# ADDENDUM NO. 1

June 7, 2021

## Provo Peaks Elementary Re-Roof

# ADDENDUM NO. 1

**E1** AREA 'B' ROOF PLAN  
A004 SCALE: 1/8" = 1'-0"

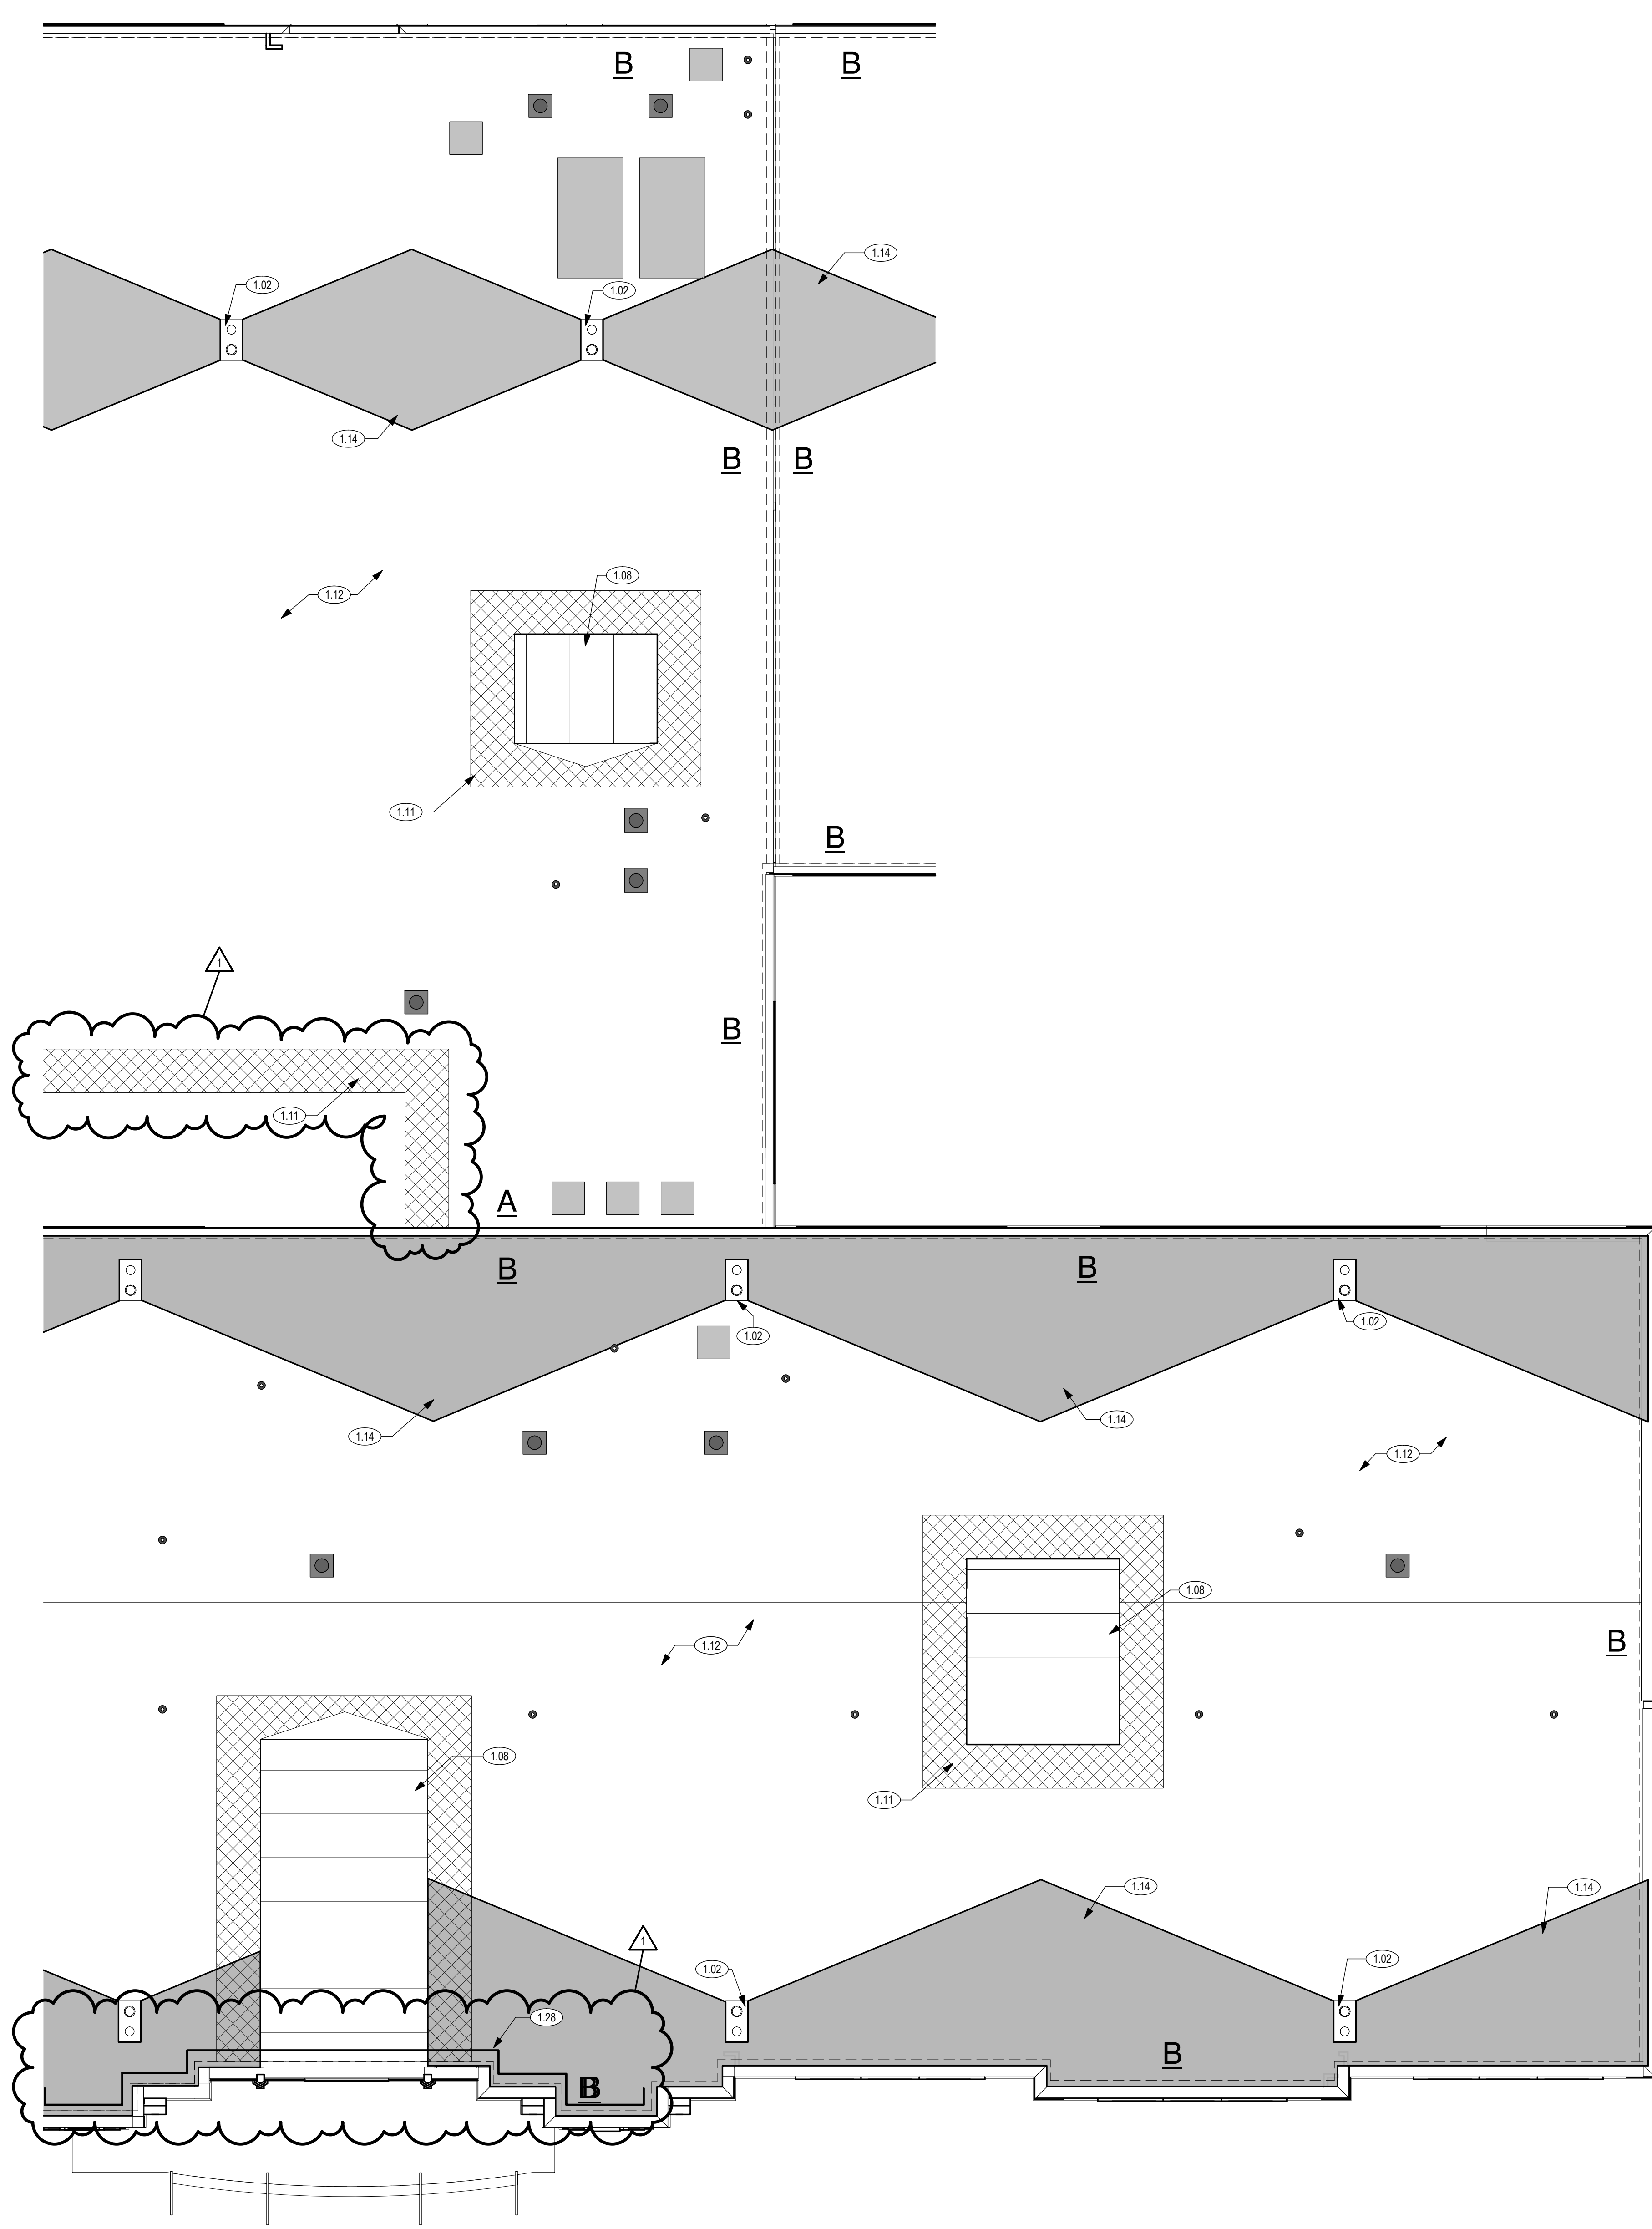
- **Revised drawings with clouds: A002, A003, A004, A005**

MARK	REVISION	DATE
1	ADDENDUM #1	6/7/2021

**ALTERNATE #1** KEEP EXISTING FLASHINGS, DRIP EDGES, AND PARAPET CAPS AND REINSTALL.

**UNIT COST #1** PROVIDE UNIT PRICE FOR POLY-ISO INSULATION FOR INSTANCES WHERE EXISTING ROOF INSULATION NEEDS TO BE REPLACED.

SHEET DESCRIPTION: AREA 'C' ROOF PLAN  
 SHEET: A005

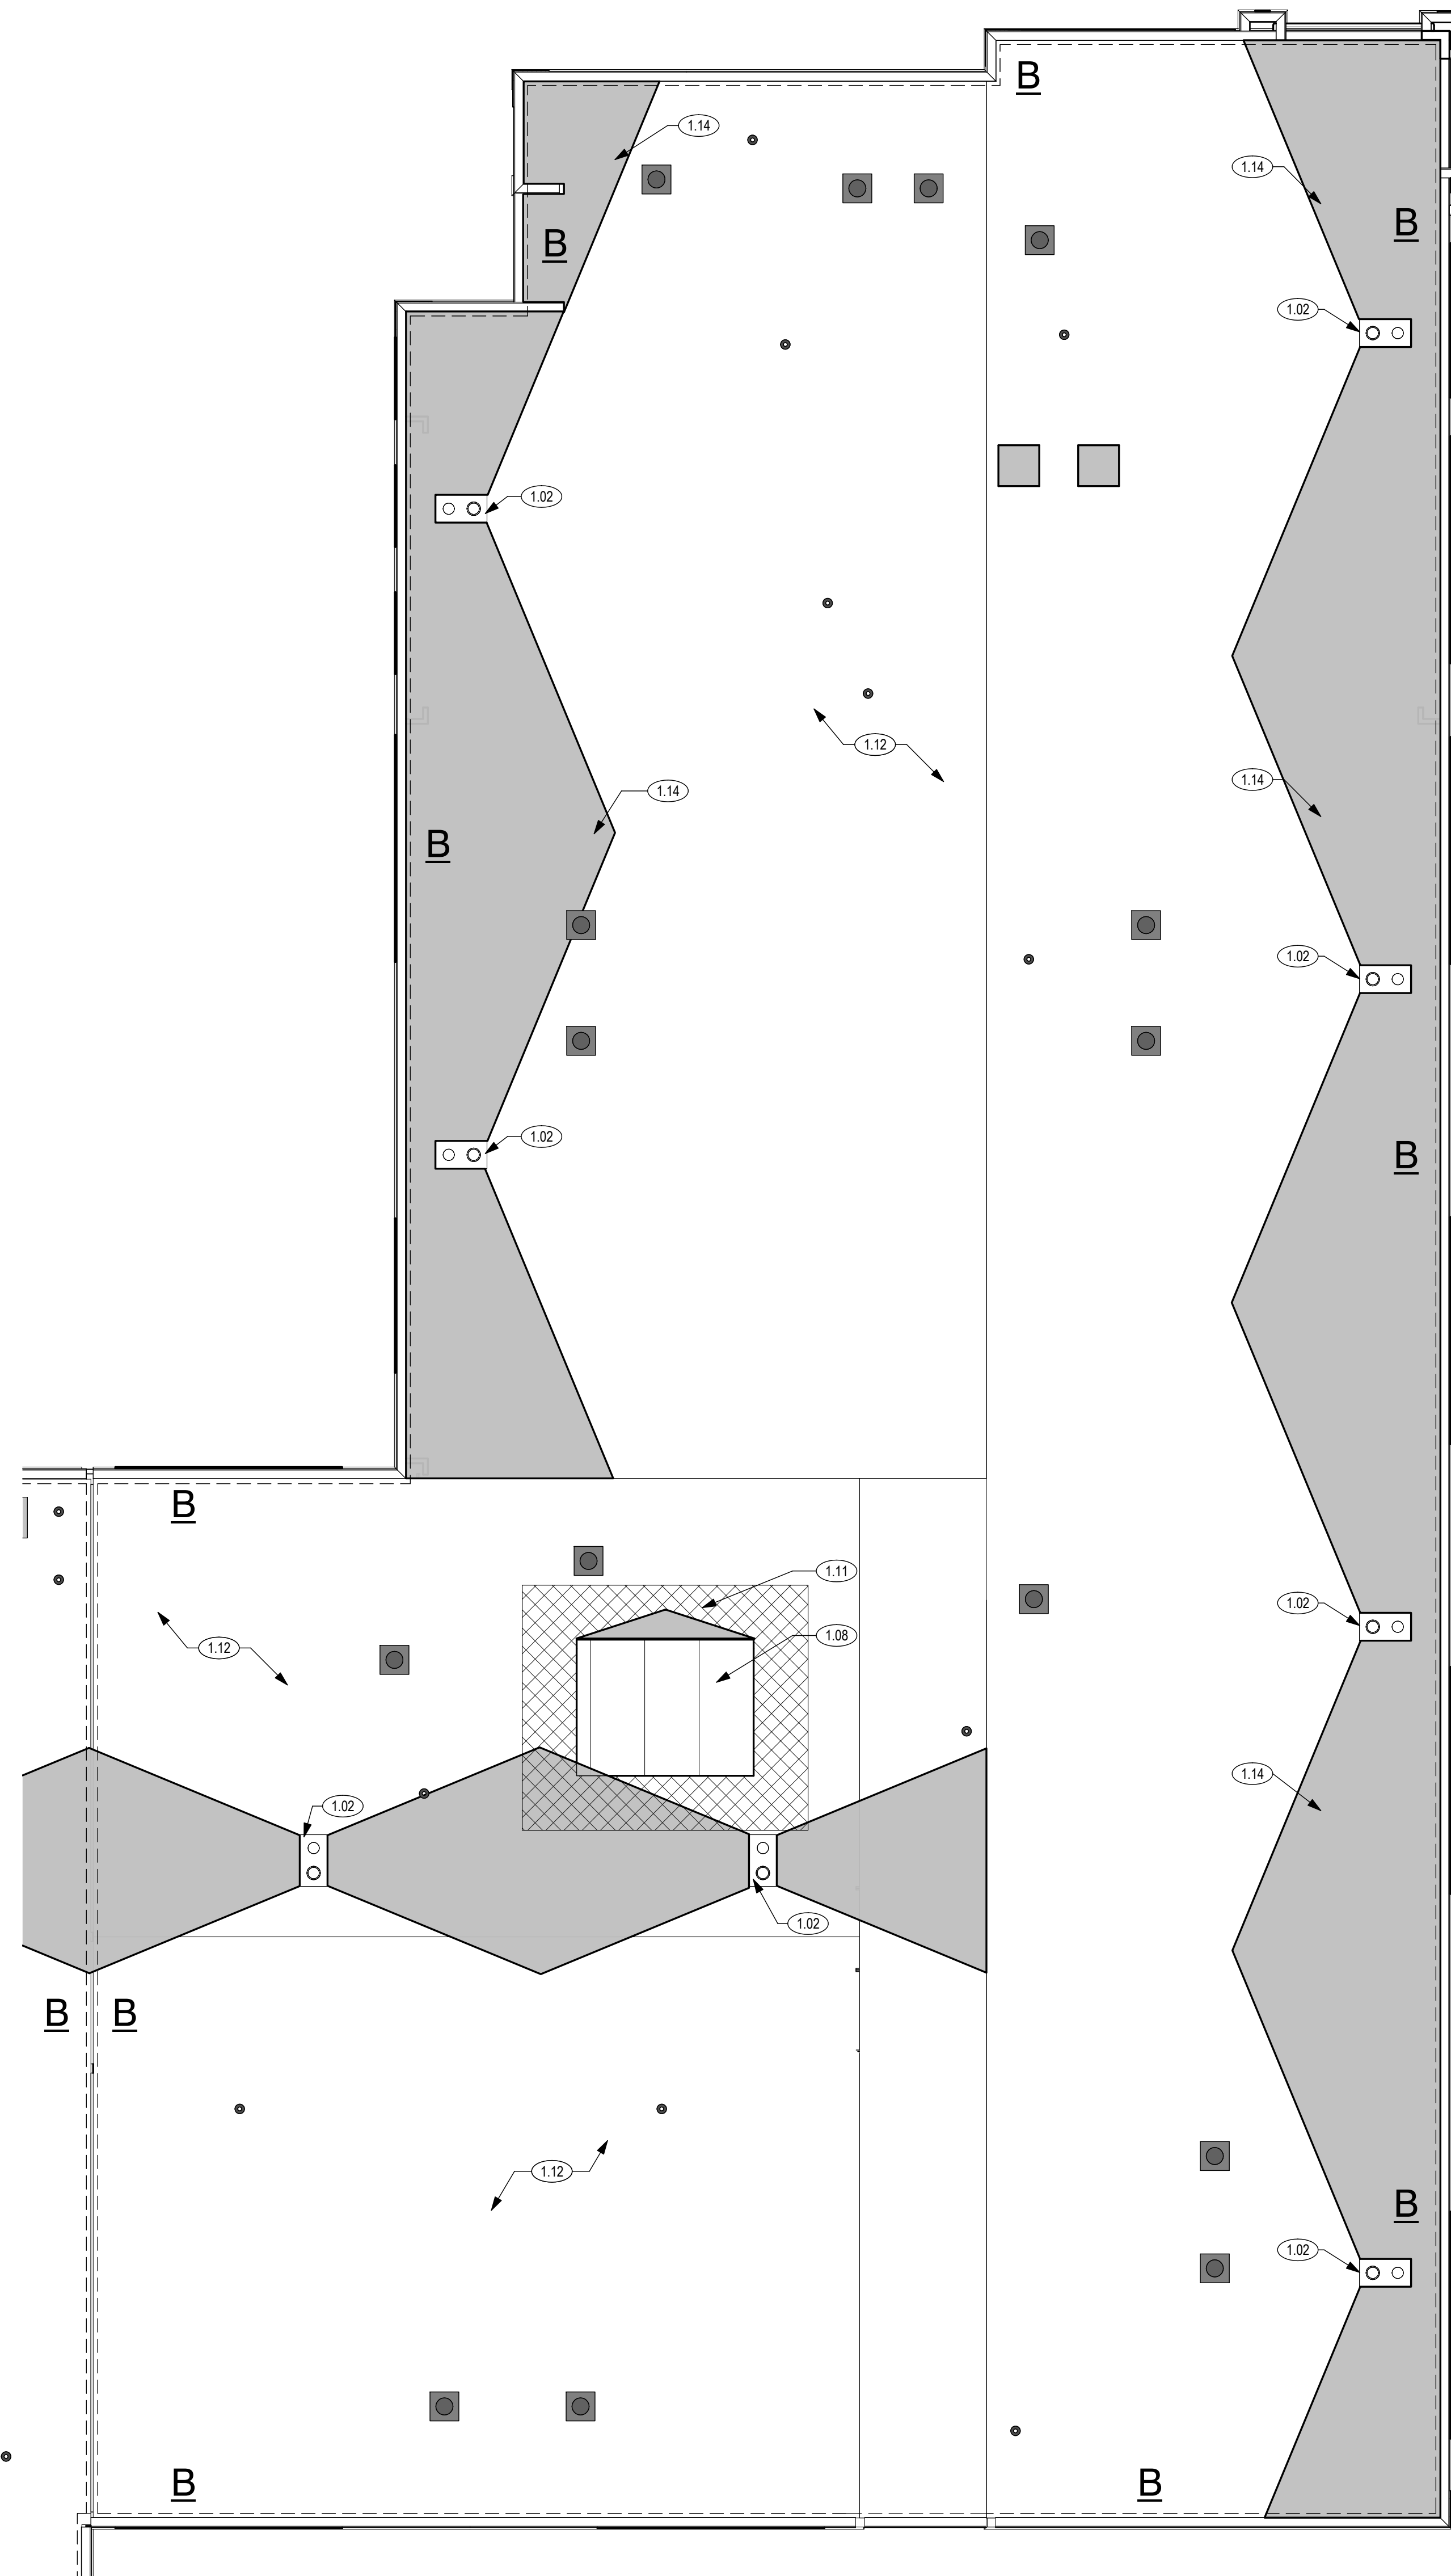
MARK	REVISION	DATE
1	ADDENDUM #1	6/7/2021

**ALTERNATE #1** KEEP EXISTING FLASHINGS, DRIP EDGES, AND PARAPET CAPS AND REINSTALL.

**UNIT COST #1** PROVIDE UNIT PRICE FOR POLY-ISO INSULATION FOR INSTANCES WHERE EXISTING ROOF INSULATION NEEDS TO BE REPLACED.
